Tyrone Operations
P.O. Box 571
Tyrone, NM 88065

July 21, 2015

**Re: Response to Little Rock Mine Expansion and Updated
Closeout Plan Comments, Revision 14-1, Permit No. GR007RE**

LITTLE ROCK MINE CCP
FIGURE 5

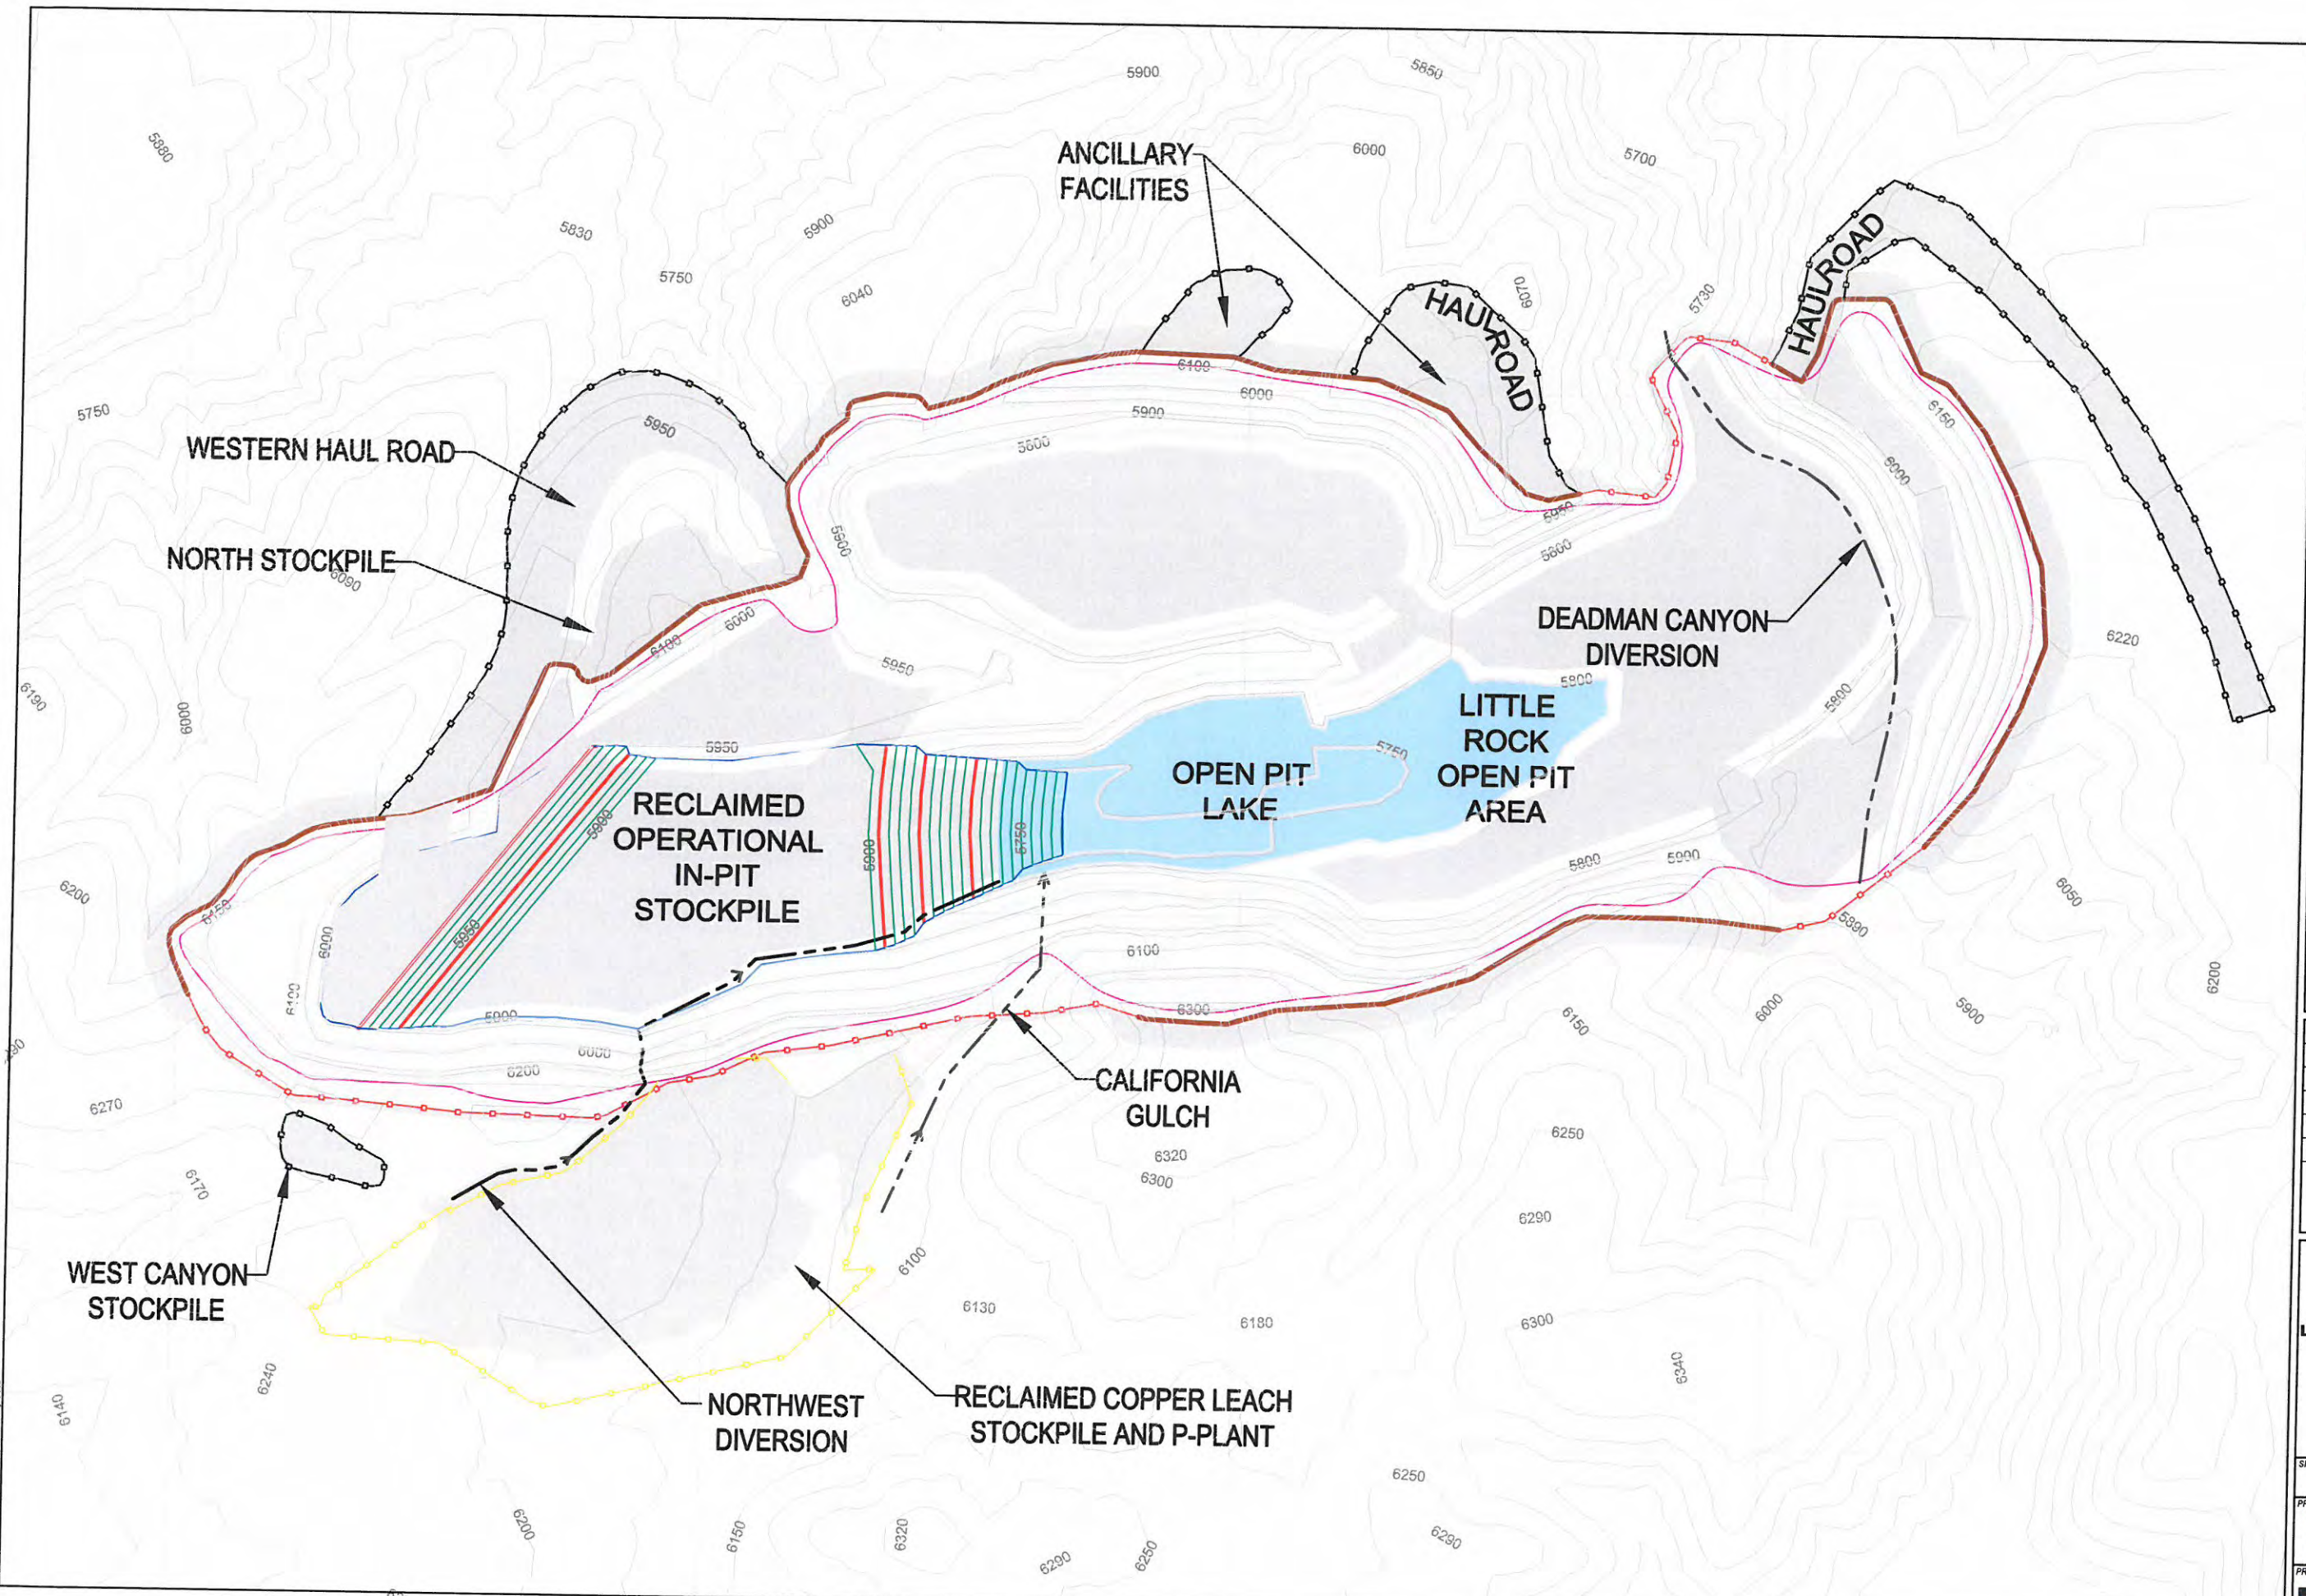
13. MMD appreciates Tyrone's effort to modify the design of the reclaimed open pit to improve wildlife access. MMD would like to discuss with Tyrone how wildlife access to the reclaimed In-pit Stockpile area depicted on Updated Sheet 5: Little Rock Mine CCP Post Reclamation, may be improved.

On July 8, 2015, Tyrone and MMD held a conference call to discuss potential wildlife access to the reclaimed In-Pit Stockpile area shown on Updated Sheet 5. It was determined that a ramp, from the Western Haul Road to the Operational In-Pit Stockpile, would be present at End of Year 2017 that was not previously shown on the drawing. This ramp would provide additional access to the stockpile. Sheet 5 has been updated to show the conceptual location of the ramp and an updated copy of Sheet 5 is attached.

The total area of revegetation was evaluated with the addition of the ramp and change to the pit lake level. The total acres requiring revegetation, including this ramp (222 acres), is less than the acreage accounted for in the Little Rock CCP Appendix B (236 acres). Therefore, no change to the FA cost estimate is proposed.
